TO: Town of Plymouth DATE: June 21, 2022  
FROM: Howard Stein Hudson HSH PROJECT NO.: 2021246.00  
SUBJECT: Brook Road over Beaver Dam Brook  
Bridge No. P-13-011 (9KM) – Peer Review & Preliminary Structural Analysis

Plymouth – Brook Road over Beaver Dam Brook Bridge No. P-13-011 (9KM)  
June 2022

**Figure 1. Existing Cross Section**

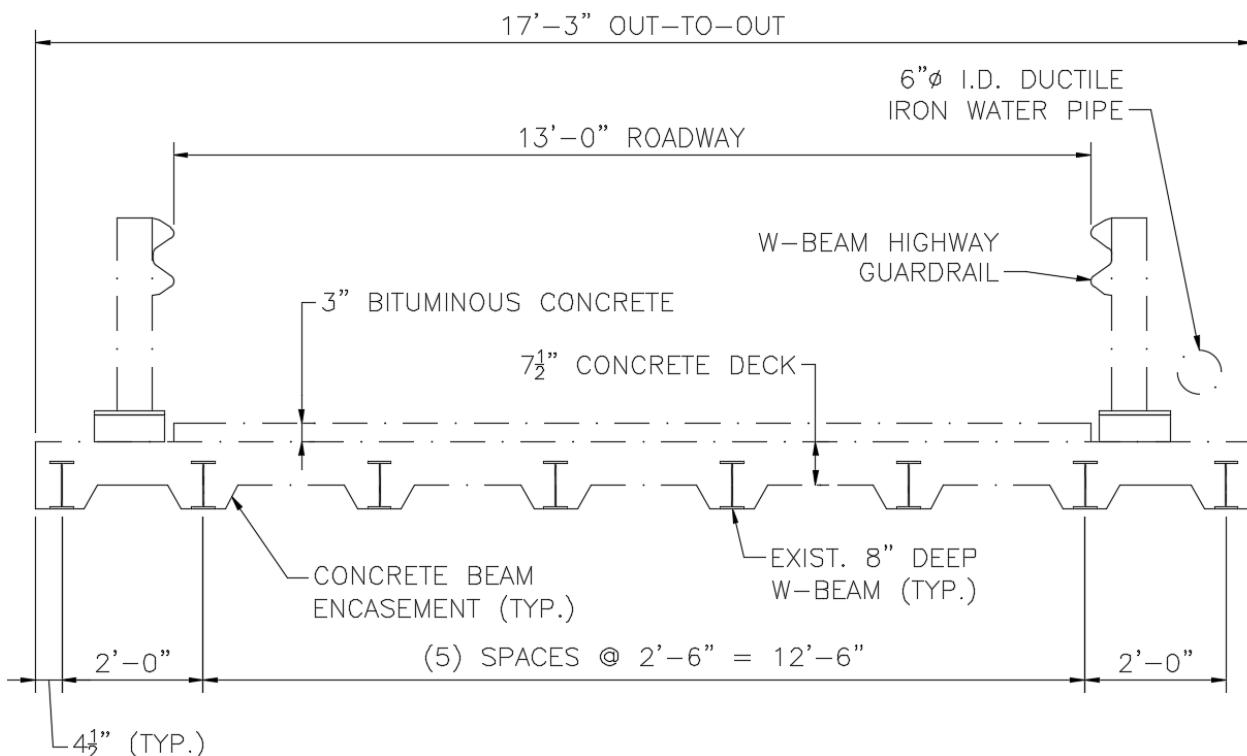
The interior beams are spaced at 2'-6" with exterior beams spaced at 2'-0" and 0'-4½" wide overhangs, resulting in a total out-to-out width of 17'-3". The existing roadway width is 13'-0" from face of guardrail to face of guardrail (see **Figure 1**). There is also a 6" diameter water line along the south side of the bridge which is supported on concrete blocks sitting on the top of the deck.

Figure 2. Proposed Cross Section

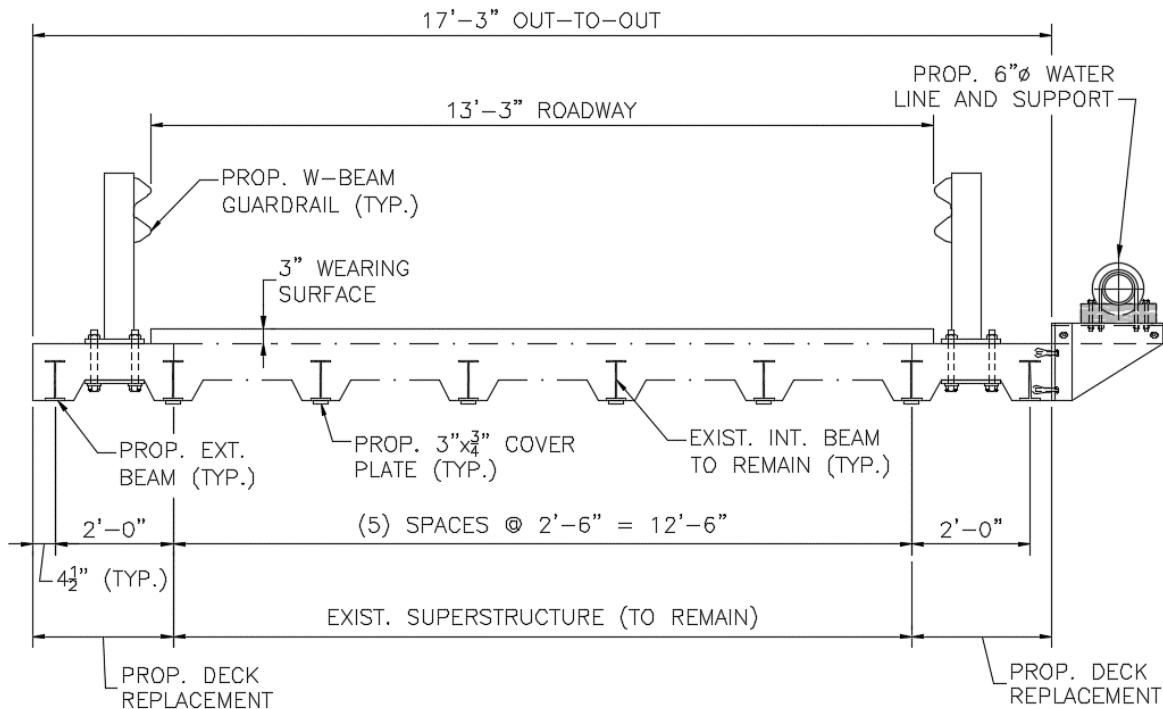
Based on the findings of the superstructure exploration, HSH has run a superstructure analysis to see if reuse of the existing steel beams and reinforced concrete deck is possible. Due to the existing deterioration of both exterior beam bottom flanges, replacement of the beam and deck would be required at these locations. The exterior beams and deck would be replaced "in kind" to negate additional loading to the existing substructure. The proposed layout would also allow for the existing waterline to be repositioned away from the guardrail, which is currently susceptible to damage in a collision event. The proposed cross section would maintain the existing overhang widths at 0'-4½", an overall deck out-to-out width of 17'-3", and utilize new w-beam guardrail resulting in a roadway width of 13'-3" (see **Figure 2**).

HSH recommends the current bridge structure be repaired by replacing the two deteriorated exterior beams and portion of the concrete deck, adding cover plates to the existing interior beams, replacing the existing guardrail, and repositioning the location of the existing water line as is shown in **Figure 2**. Additional repairs would also include patching the deck, re-pointing stone masonry substructure, and leaning wingwall deficiencies noted previously. Performing these repairs would address the deficiencies listed in the August 10, 2020, *Routine Inspection Report* and allow the existing structure to be re-opened to traffic with a revised load posting to be coordinated with the MassDOT District 5 office. Repairing the existing structure would also provide additional benefits as opposed to a complete bridge replacement (see **Table 3** for comparison of the two options).
